## **National Paediatric Hospital Development Board**

**Project No.: 011782**

## **Emergency Department Concept Options Analysis**

EMERGENCY DEPARTMENT - OPTION 3

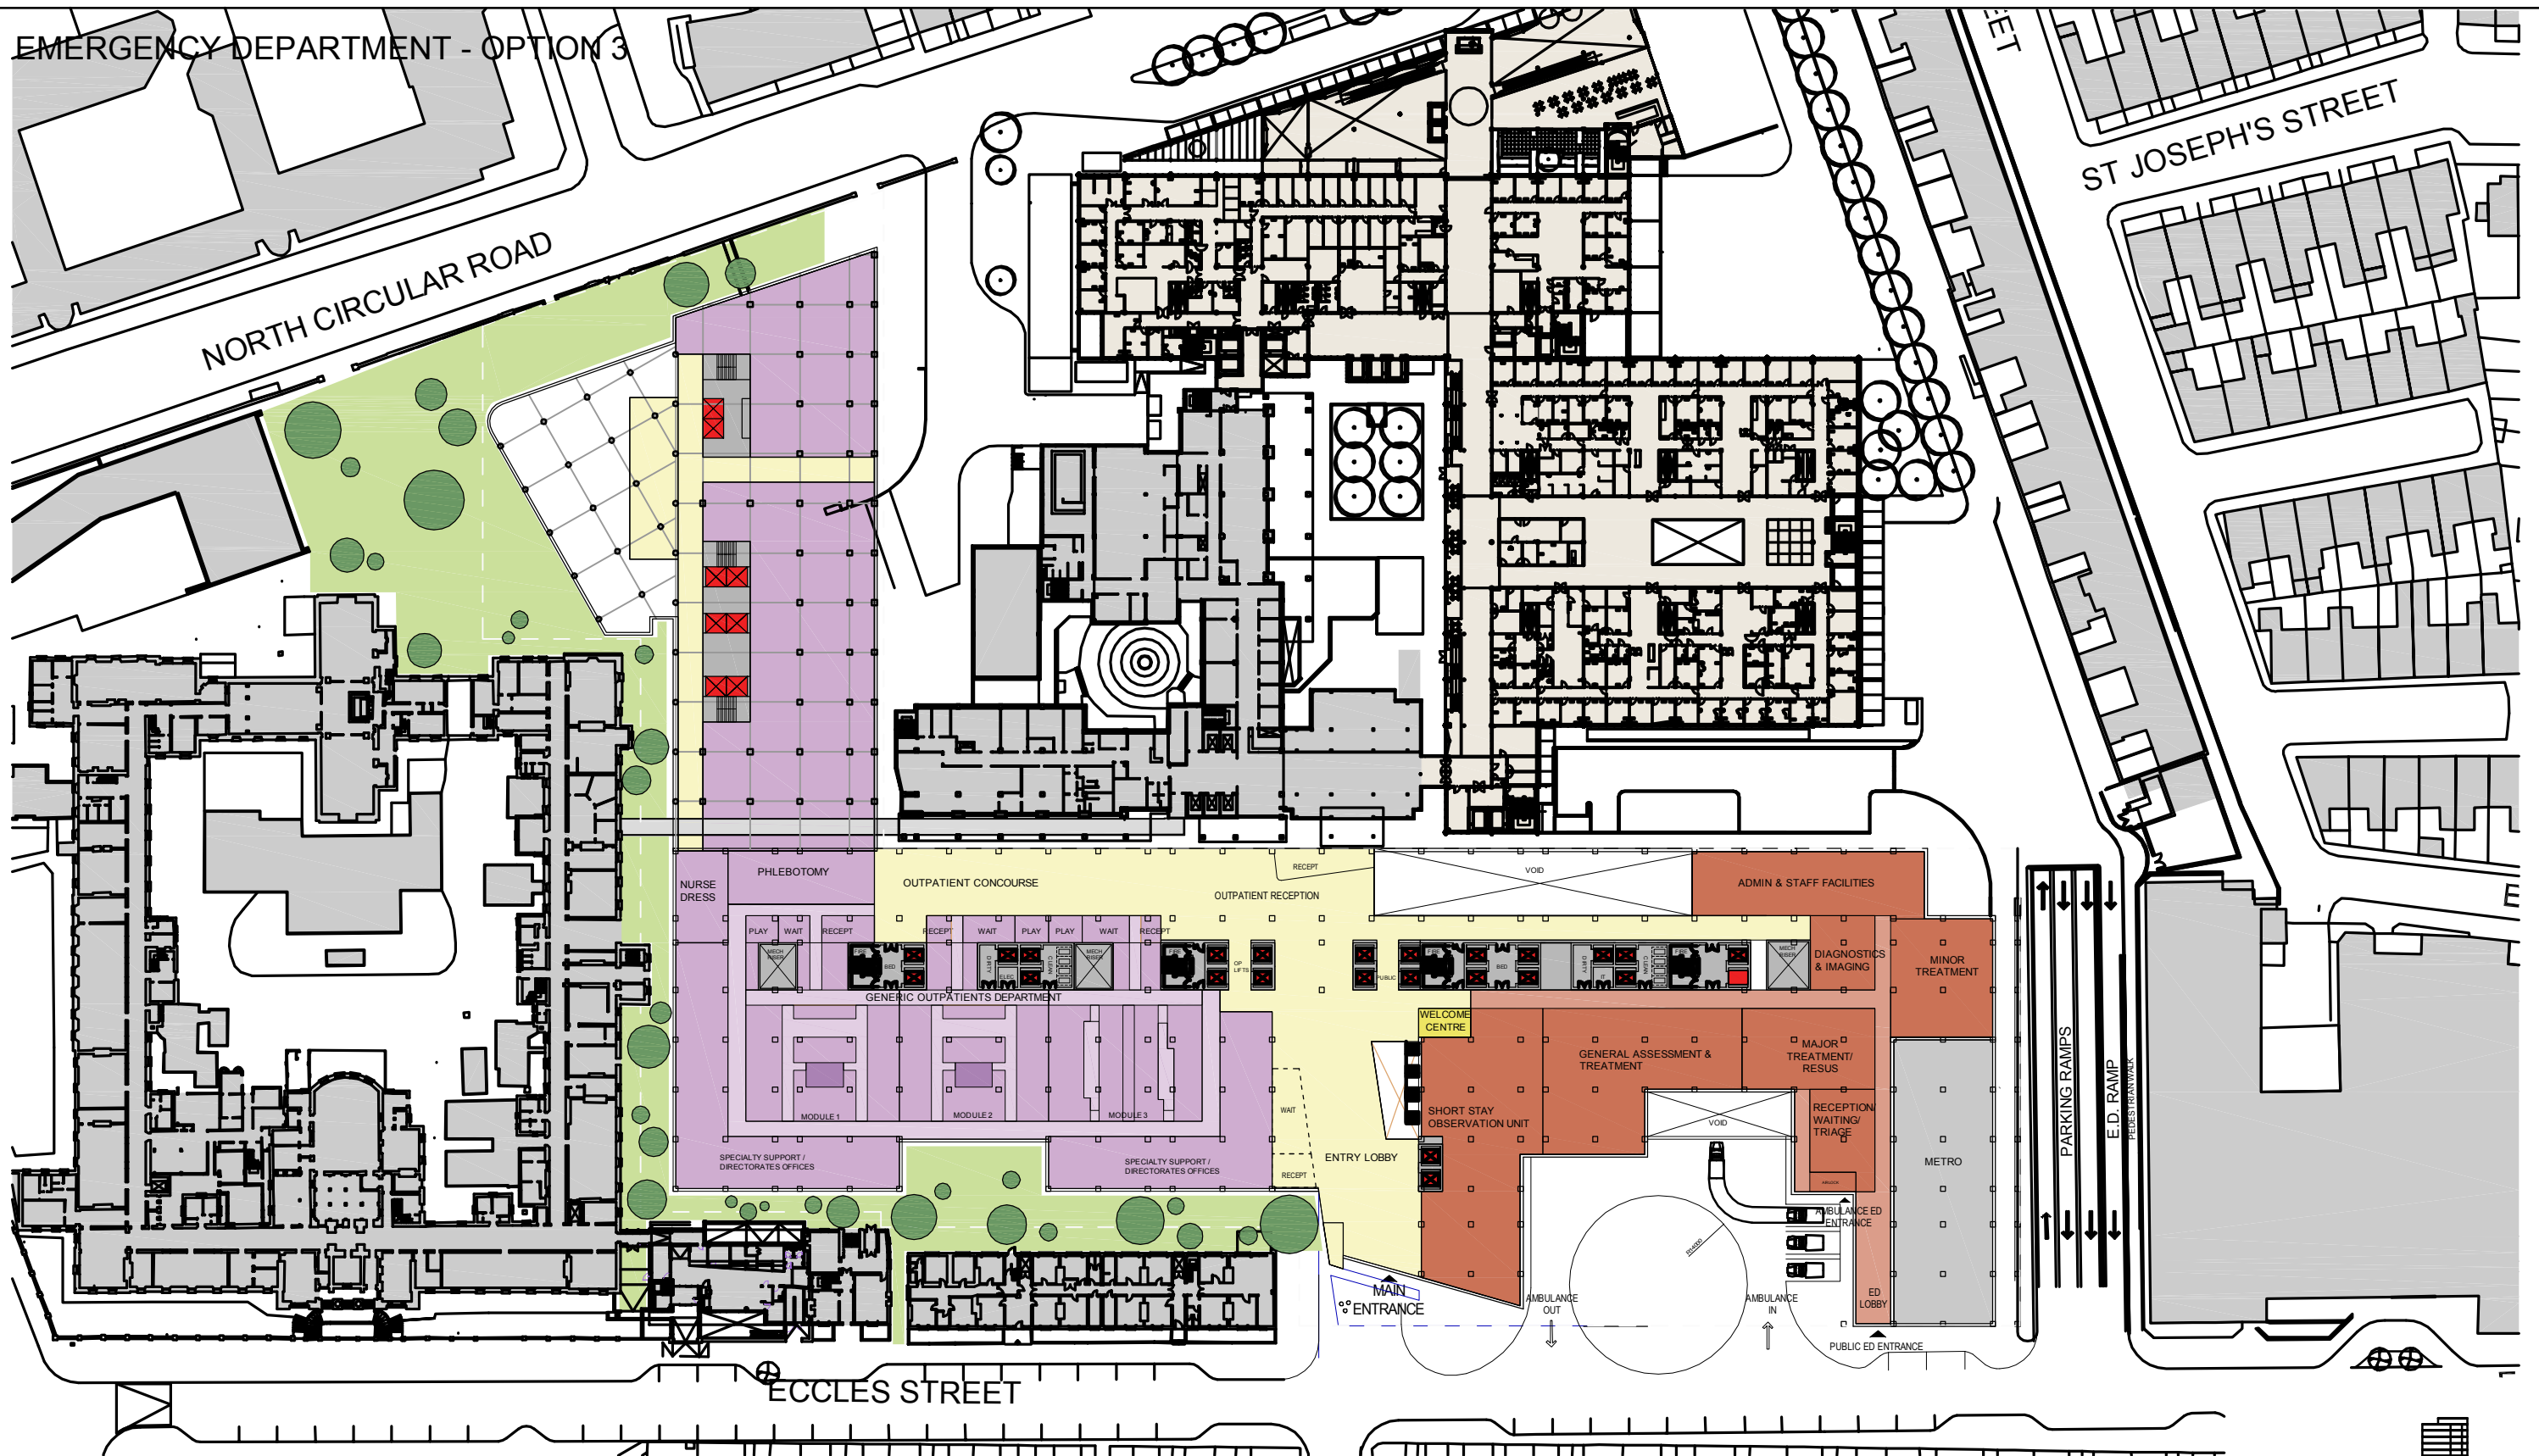
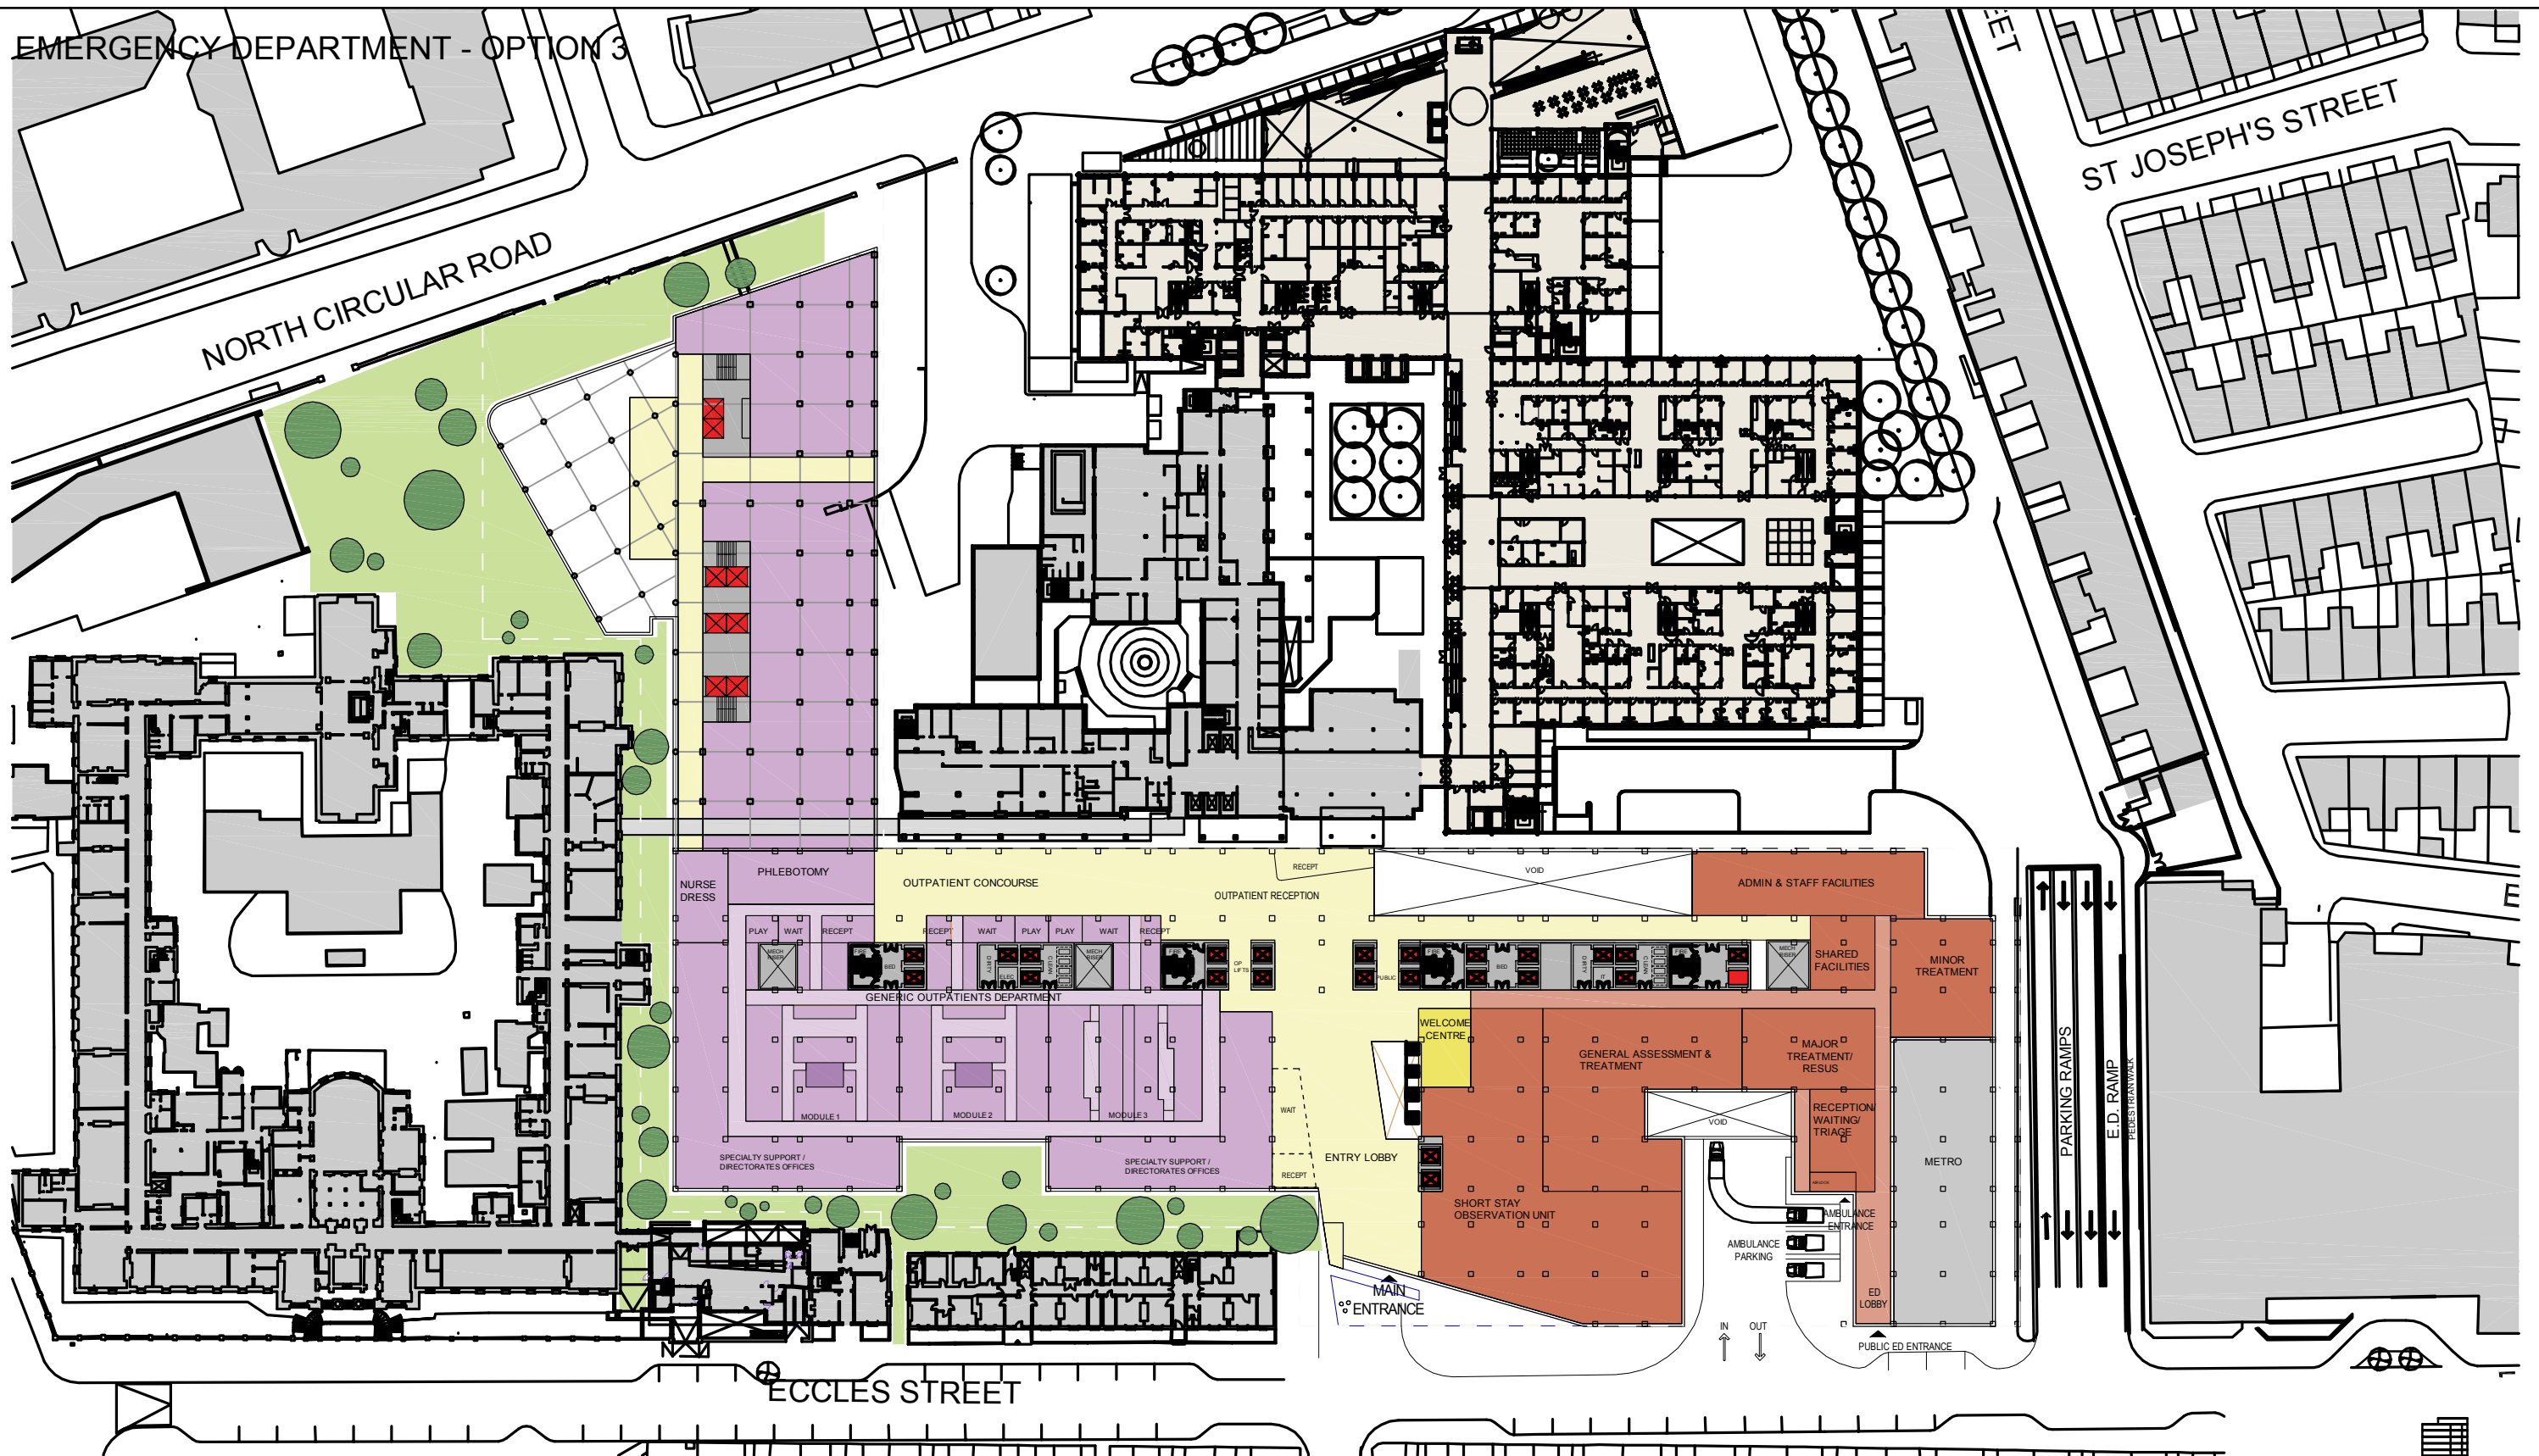
1. Options 1, 2 and 4 are preferable over Option 3-2 for the following reasons:
  - a. In our view there is a higher risk associated with the proximity of the metro entrance and associated pedestrian traffic in Option 3-2 due to the requirement to cross the ambulance entrance bay.

- b. Option 3-2 requires an additional extra significant pedestrian crossing point over options 1,2 and 4.
  - c. Due to the proximity of the metro entrance there is a higher probability of pedestrians trying to gain access to the Emergency Department through the ambulance bay and therefore mixing with vehicular traffic.

- d. Considering that ambulances will already be exiting from the Mater Adult Acute Hospital using the exit for Options 1,2 and 4, Option 3-2 only serves to add an additional ambulance exit point and therefore an additional collision risk point.

- e. Option 3-2 provides for a vehicle bay that is more open to the public and thus the risk of pedestrian/vehicle collisions and in particular from reversing vehicles is increased over the other three options due to the fact that the ambulance bay is more "private".

We do not recommend option 3-2 at all.

# EMERGENCY DEPARTMENT - OPTION 4

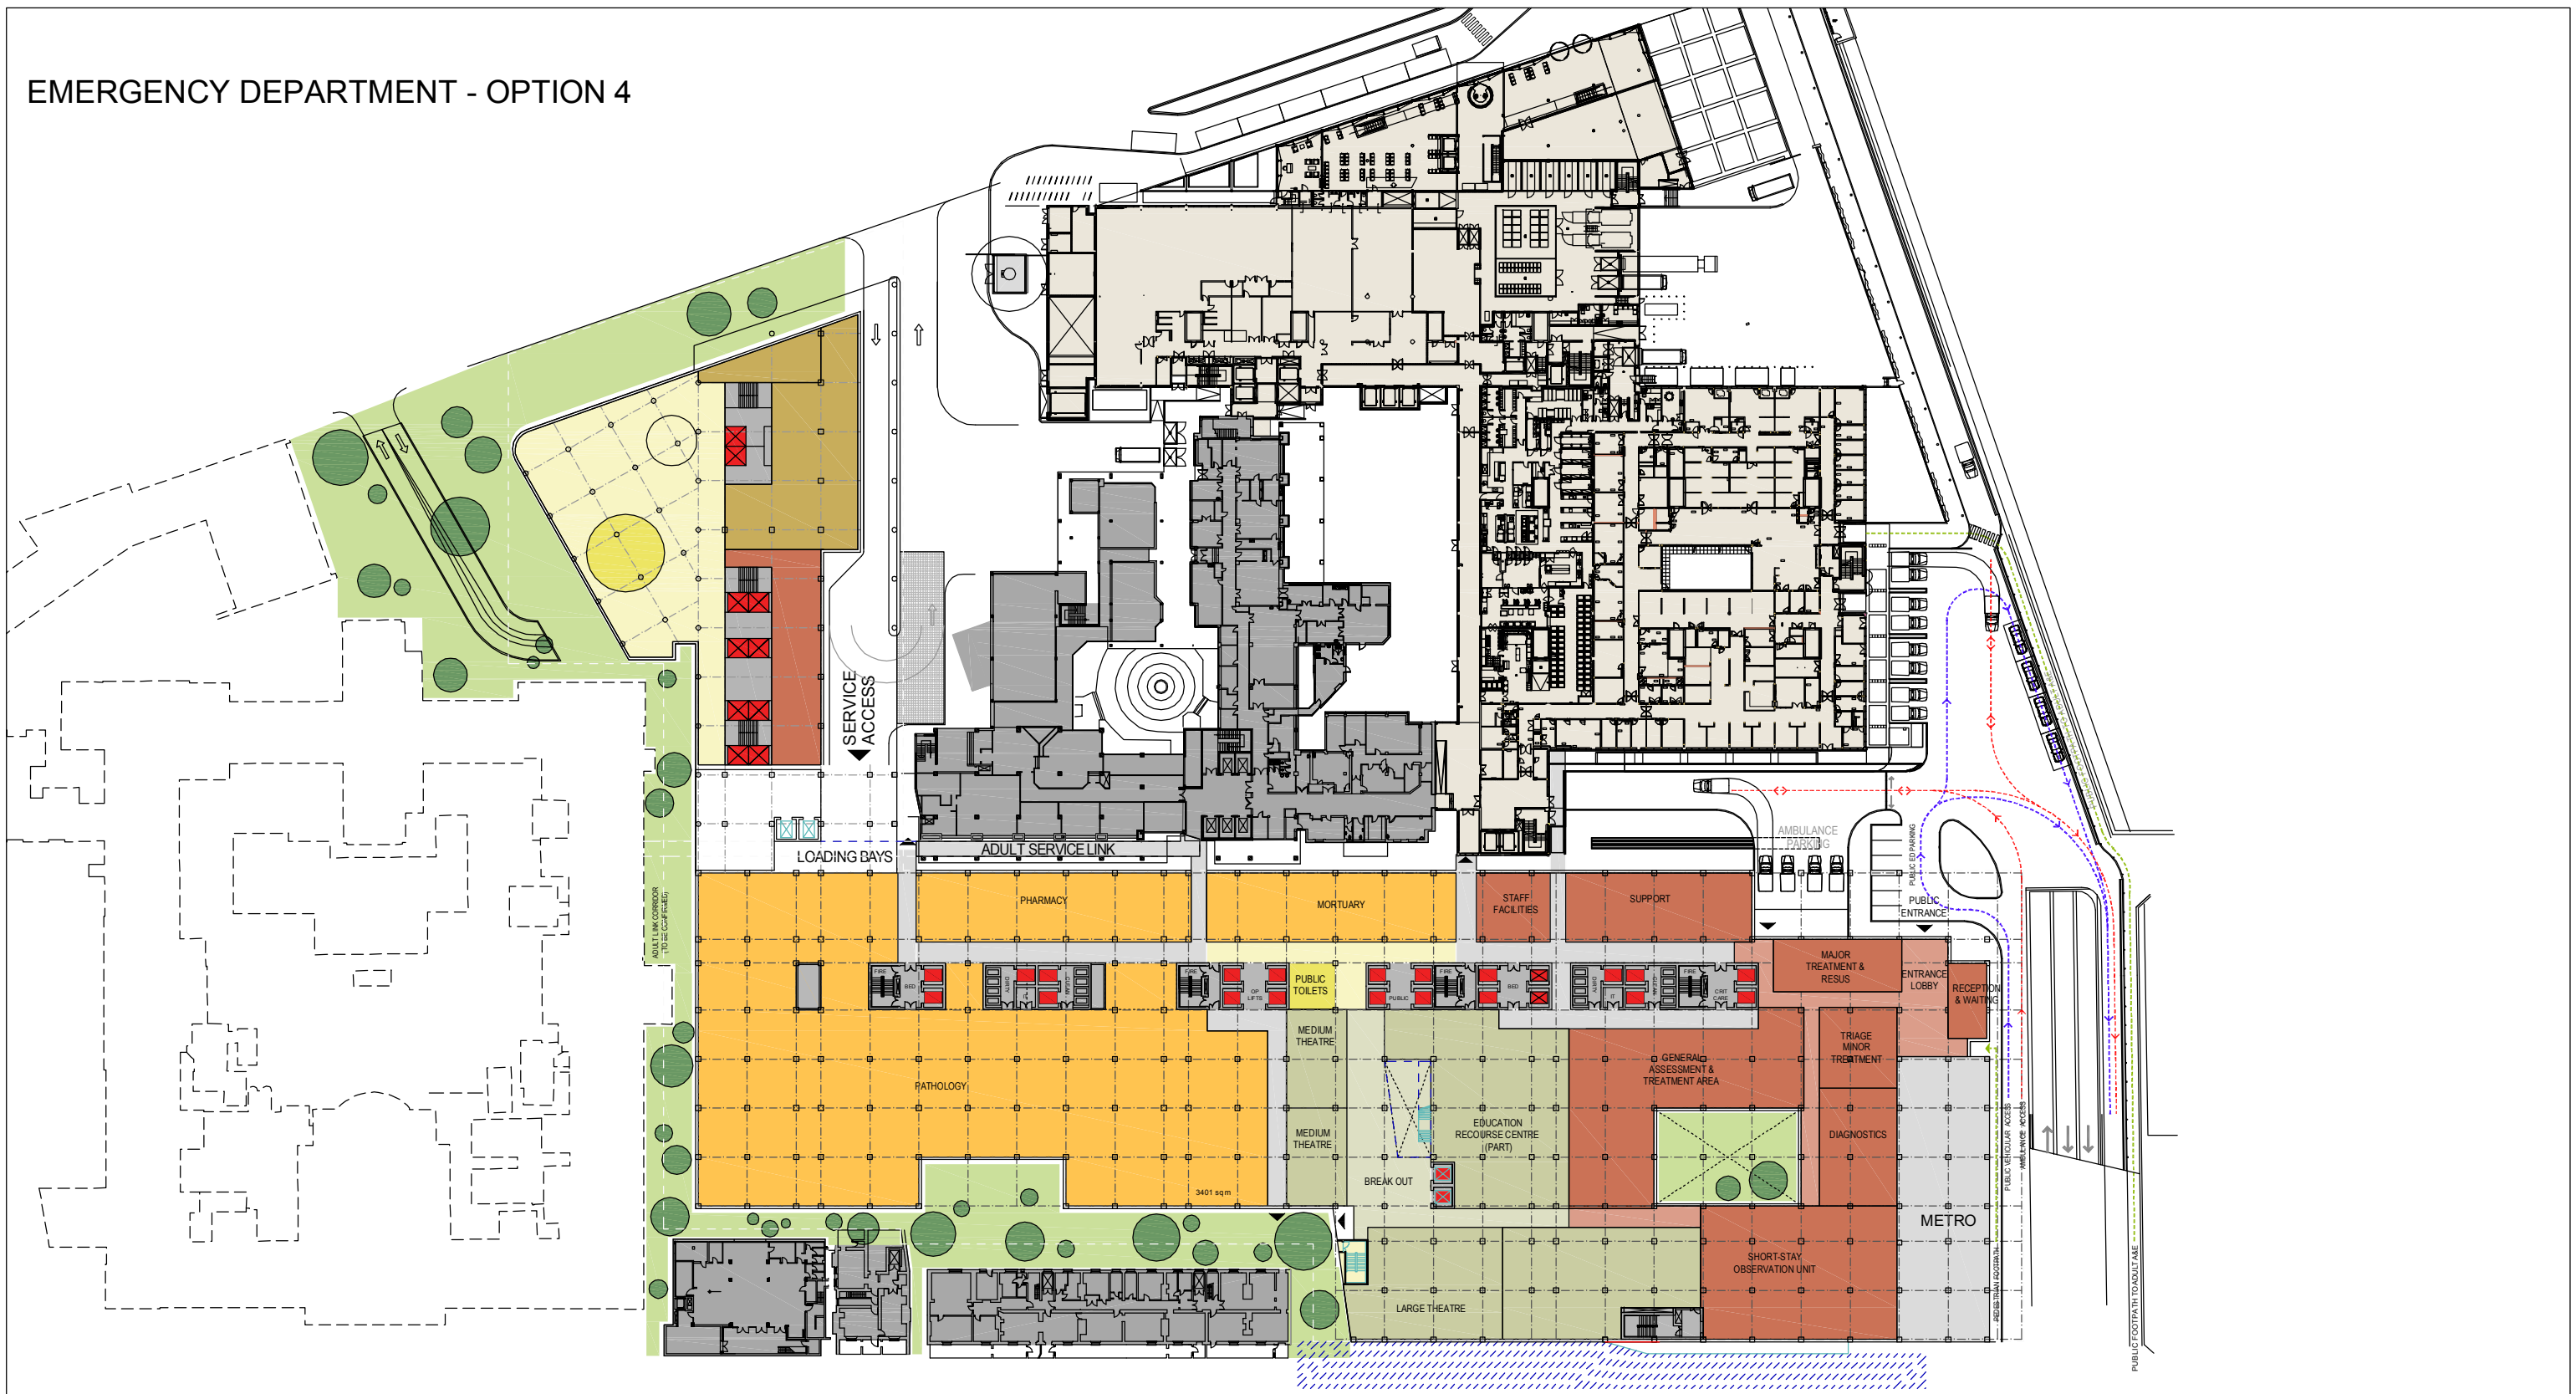
4. The adjacency of the public entrance and ambulance bay at Option 4 also introduces the risk of vehicle/pedestrian collisions though to a lesser extent than option 3-2. This is exacerbated by the fact that Adult Hospital Ambulances as well as private vehicles would also be using the area. Given the high likelihood of people been in a distressed state and communicating via mobile phone to family members people are more likely to be distracted increasing the risk of vehicle/pedestrian collisions.
